1. 7:00 P.M. Historic District Commission Regular Meeting

HDC Work Permit Staff Review

Property address: 301 N Hamilton (408 Emmet)

Proposed work: Small cell communication system.

C2

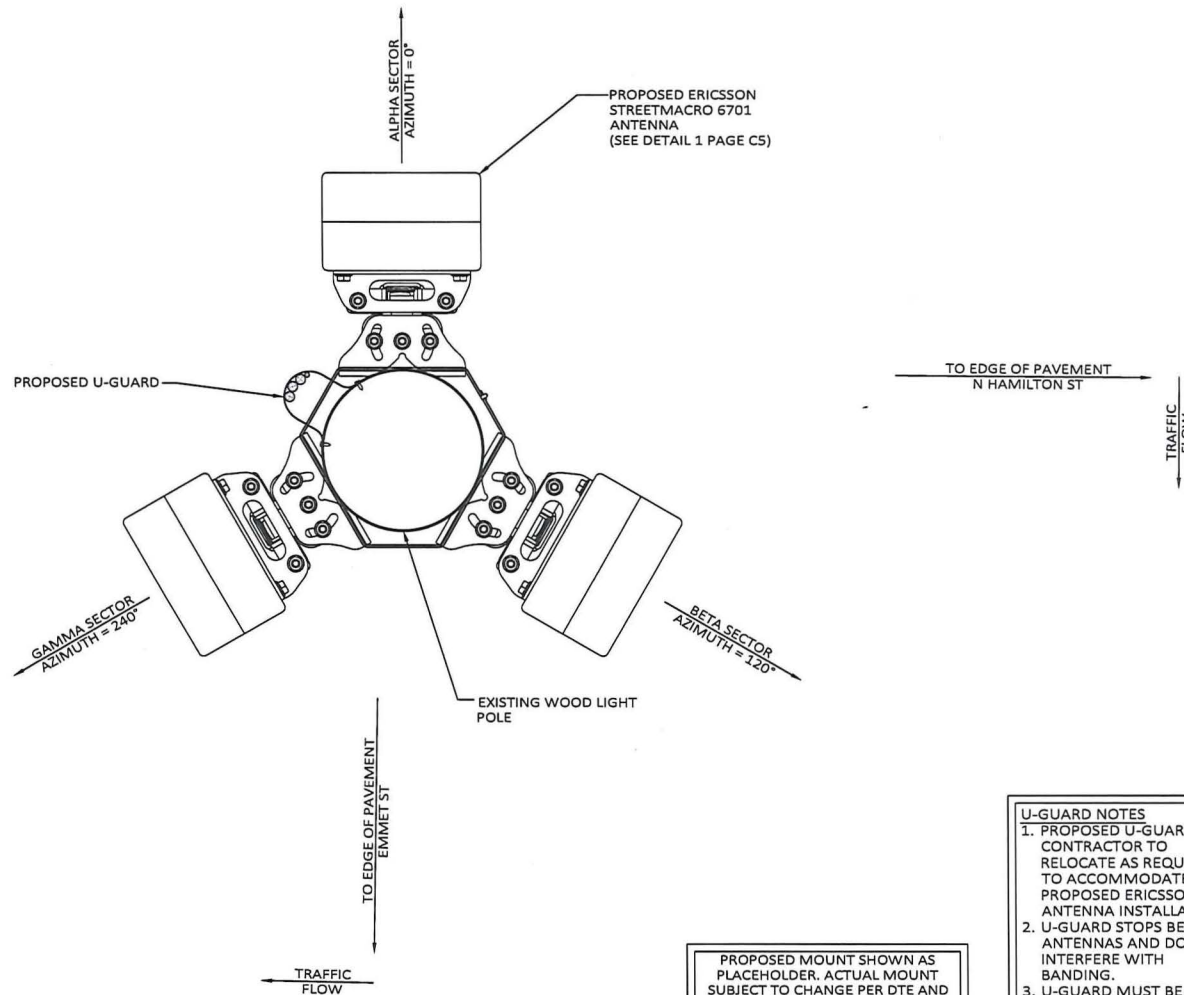
1. The application replaces an existing wood light pole with a similar one.
 - a. The existing pole is 28'4" tall, and the new pole will be a little over 10' taller, at 38'6."
 - b. The pole will include a light mount to match the existing feature.
 - c. The pole will be surmounted by a small cell communication feature, consisting of three antennas.
 - d. A caution sign will be placed between the light fixture and antennas.
 - e. Various connection boxes will be placed 10' above ground level.
2. The Michigan State Historic Preservation Office (SHPO) reviewed this project as part of required Section 106 documentation.

Move to approve and issue a certificate of appropriateness for the work at 301 N Hamilton as submitted in the application, dated February 7, 2020, for installation of a 38'6" wood pole, light fixture, antennas, and connection boxes, as specified.

1
A501
ALTERNATIVE EAST ELEVATION
1/4" = 1'-0"

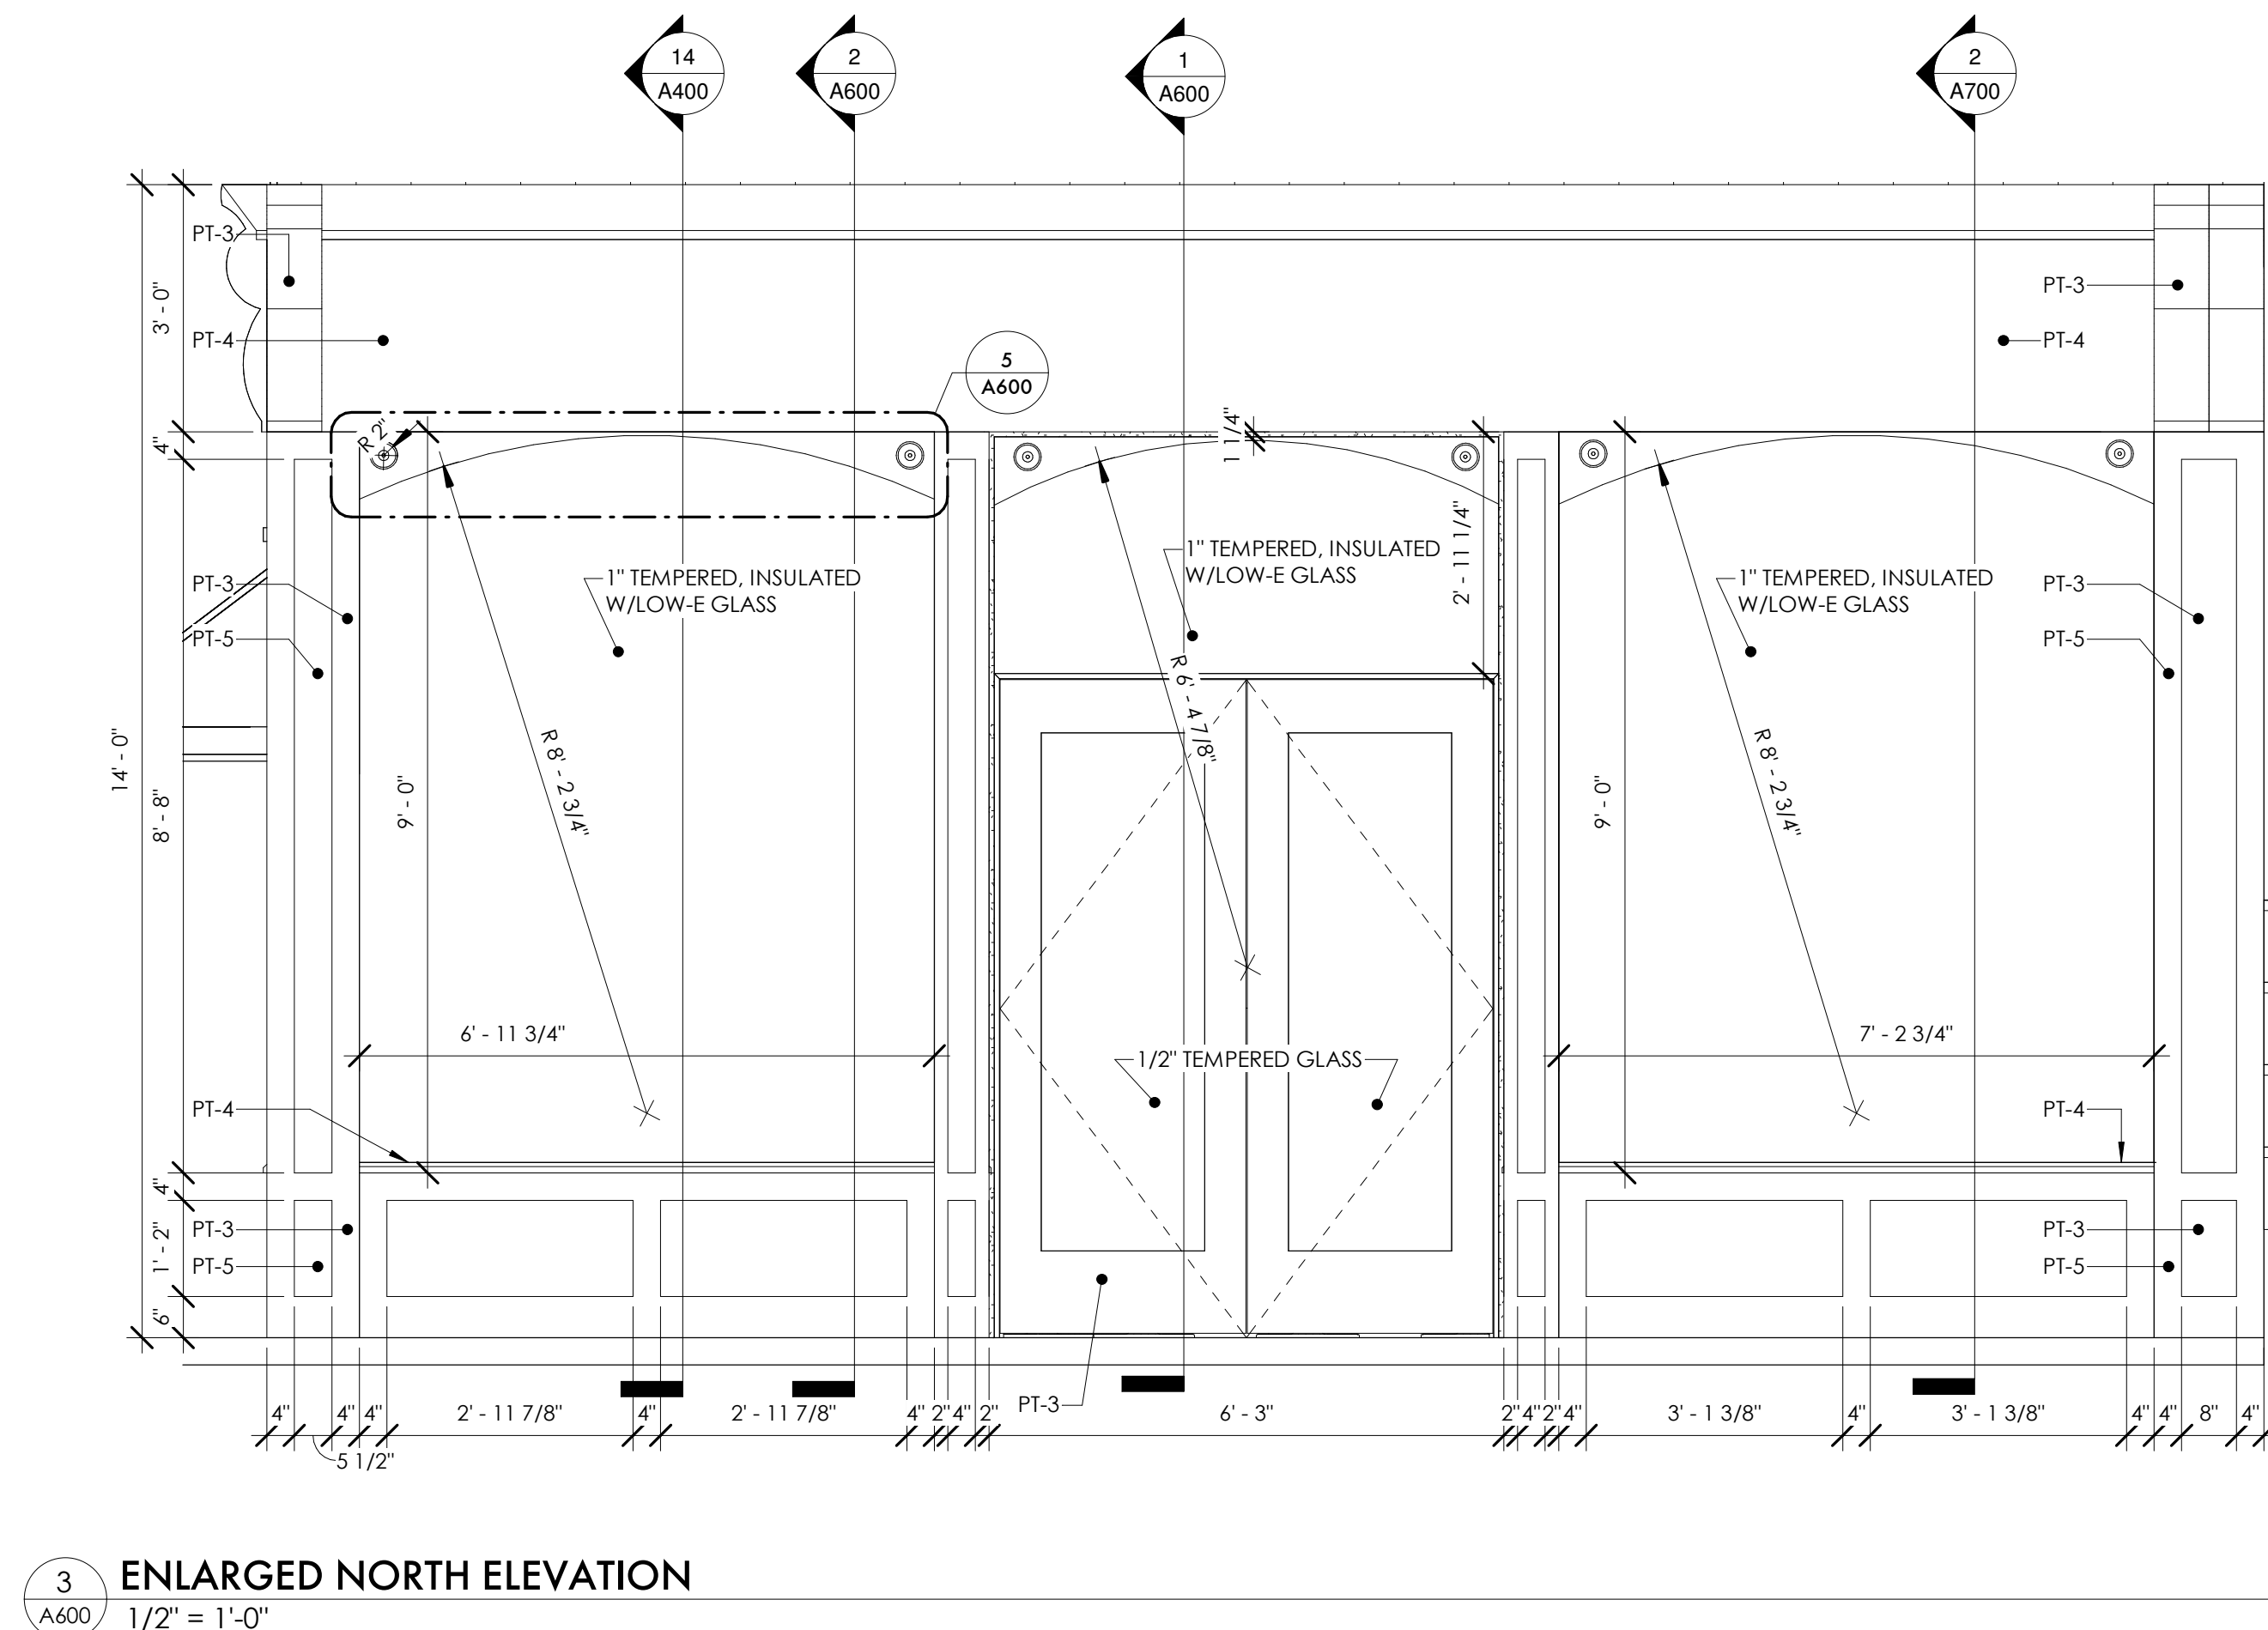
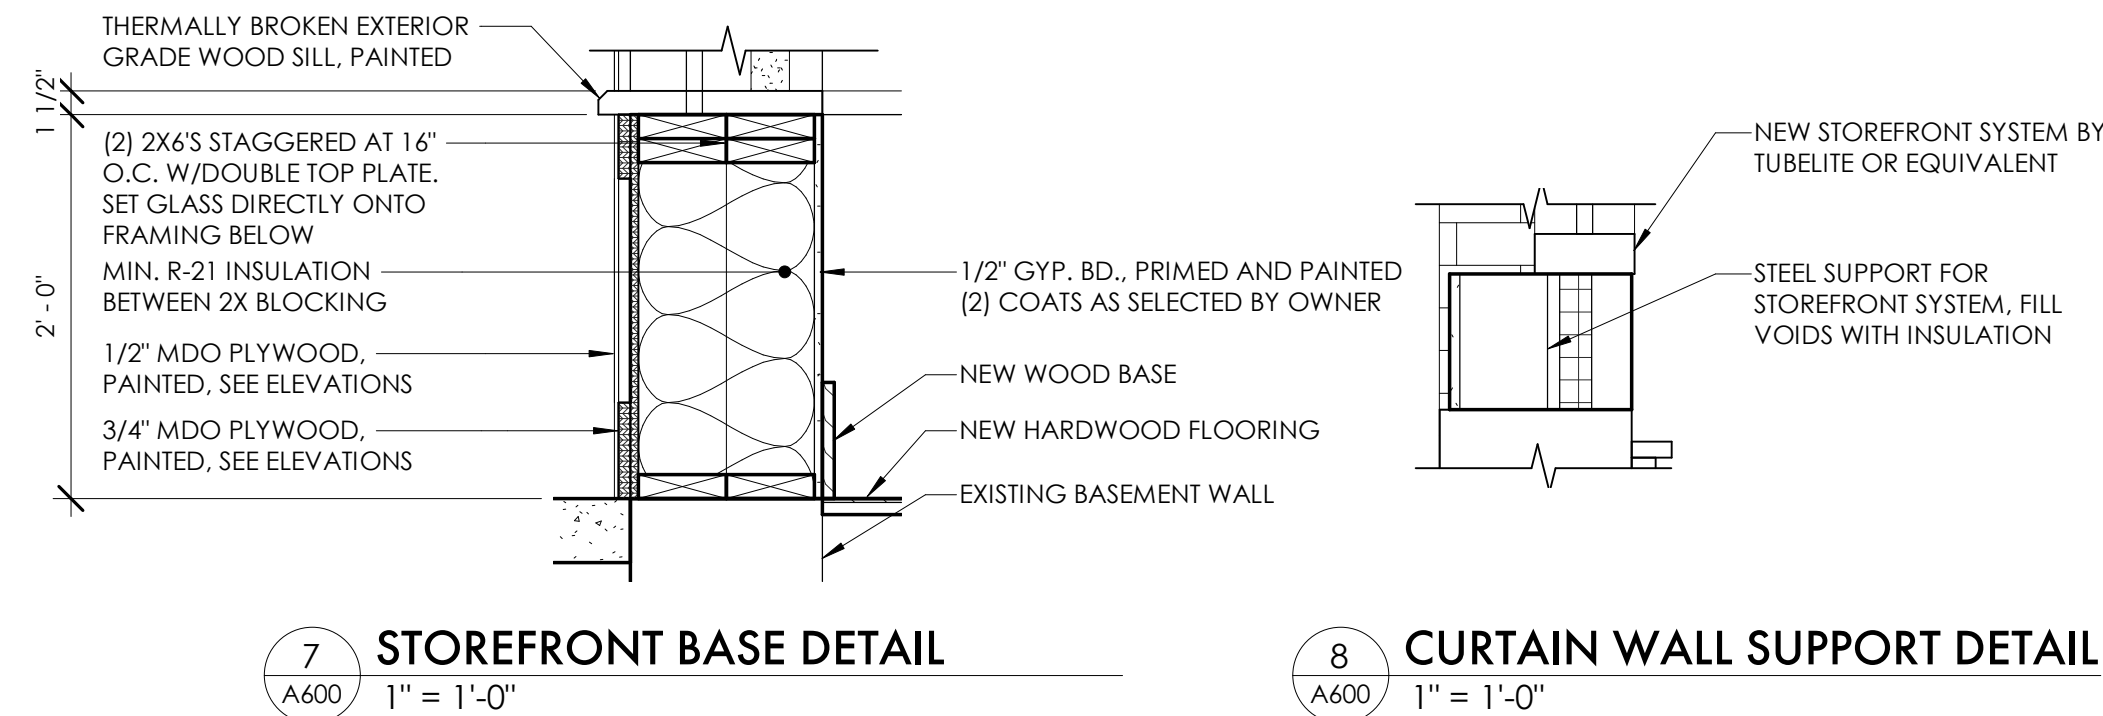
Motion: Stevenson (second: Swift) moved to table action on the proposed work at 101 West Michigan for the applicant to provide additional information on the location and dimensions of the proposed signs, and the style, location and mounting of the proposed light fixtures.
